**APPLICABLE TO ALL CARTER API STYLE
HYDRANT COUPLERS***

PN700092705
Revised May 26, 2006

EXCESSIVE WEAR CAN CAUSE COUPLER EJECTION

FIGURE 1 - RESULTS OF WEAR ON COUPLER/HYDANT INTERFACE

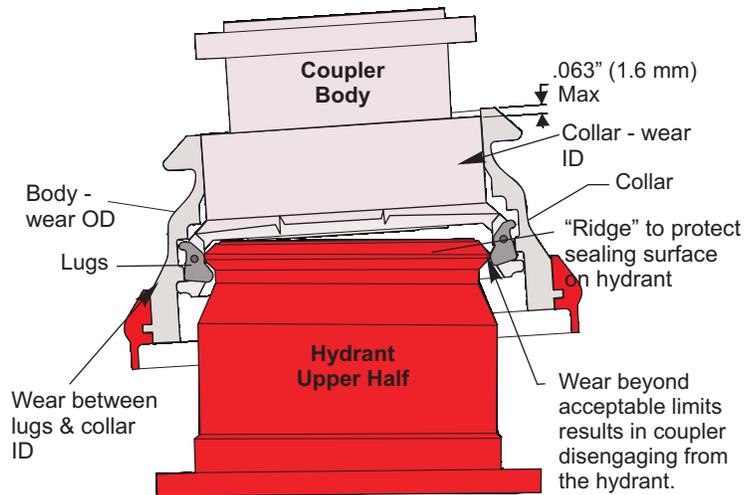
Figure 1 (top right) shows the results of an excessively worn Coupler and how the collar shifted from the centerline and rotated around the lugs directly opposite the operating handle. The surface where the collar ID contacts the coupler body OD must be excessively worn for this to occur. This rotation results in the Collar lifting on one side (directly opposite the operating handle) .100 of an inch (2.5 mm) or more when the coupler is pressurized. When the Collar is lifted, the latching lugs become partially unsupported and the lugs start rotating toward the disengaged position. The lugs are made of 7075-T6 aluminum with an ultimate strength of 83,000 psi, and the collar is a casting made of 356-T6 aluminum with an ultimate strength of 30,000 psi. As pressure increases the lugs (being stronger) rotate and deform the internal ring in the collar until the collar is lifted to the full disengaged position and the coupler separates from the hydrant valve.

FIGURE 2 - INSPECTION PROCEDURE

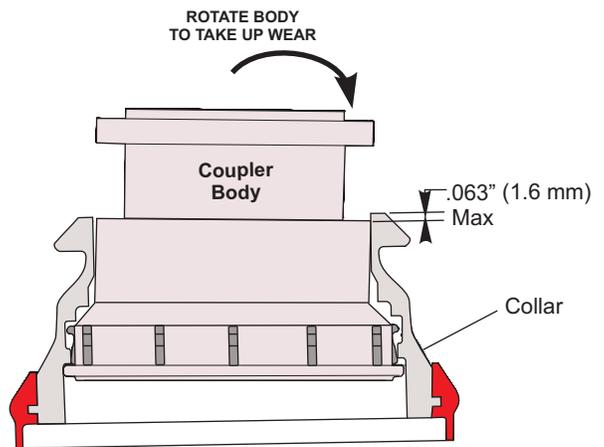
B. See Figure 2. Using hands only (no tools), push down on one side of the collar to hold it stationary relative to the coupler body, while simultaneously lifting firmly upward from beneath the collar on the coupler's opposite side. This action takes up the clearance between the housing and collar. If these components are worn, this will result in the top of the collar lifting away from the coupler housing, which normally is flush with the collar. Take note of the offset of the collar relative to the housing (directly opposite the operating handle). Refer to Figure 2, and if the offset exceeds .063 inch (1.6 mm), the coupler has too much wear for continued use. On a new coupler these surfaces would be flush or the housing would be slightly proud of the collar by approximately .025 inch (.6 mm) due to manufacturing tolerances.
